**SUNDRY NOTICES AND REPORTS ON WELLS**  
*Do not use this form for proposals to drill or to re-enter an abandoned well. Use form 3160-3 (APD) for such proposals.*

8. Well Name and No.  
OTTAWA AOW FEDERAL 1

Yates Petroleum Corporation plans to plug and abandon this well as follows:

WELL NAME: Ottawa AOW # 1 FIELD: Dagger Draw

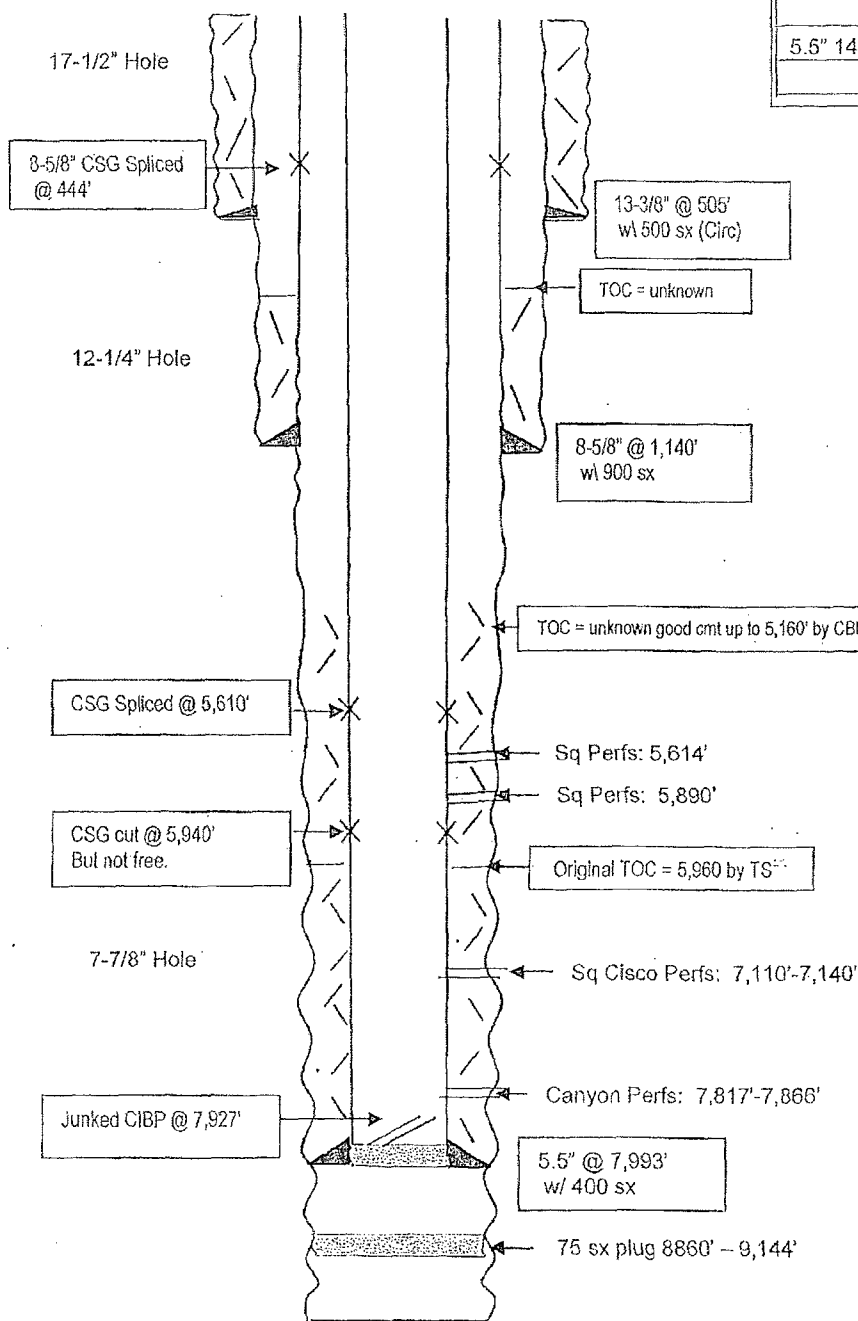
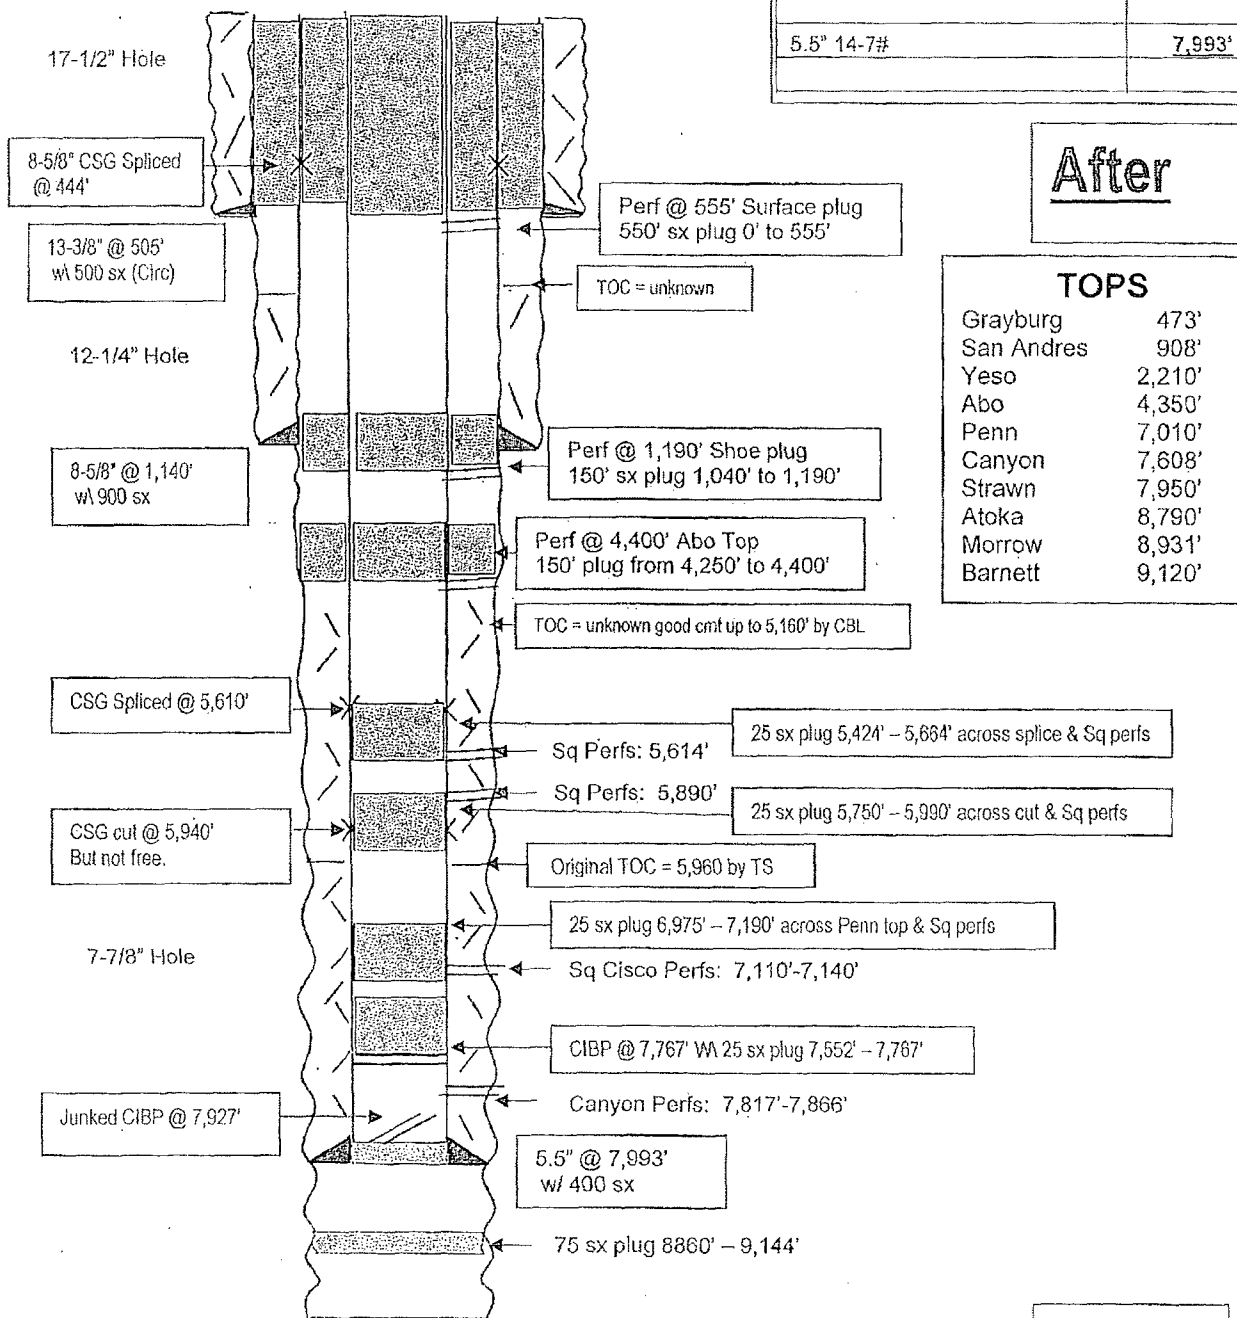
from 5424 ft - 5664 ft. This will leave a plug across casing splice at 5610 ft and squeeze perfs at 5614 ft. *WOC Tag*

7. Perforate at 4400 ft. Load hole with plugging mud, pressure test perfs to 500 psi, if they hold pressure spot 150 ft plug inside the casing, if not spot 150 ft plug inside and outside casing from 4250 ft - 4400 ft. WOC and tag plug, reset if necessary. This will leave a plug across Abo top. *Add Yeso plug from 2260 (Perf) SQZ cnt to 2140. WOC Tag*
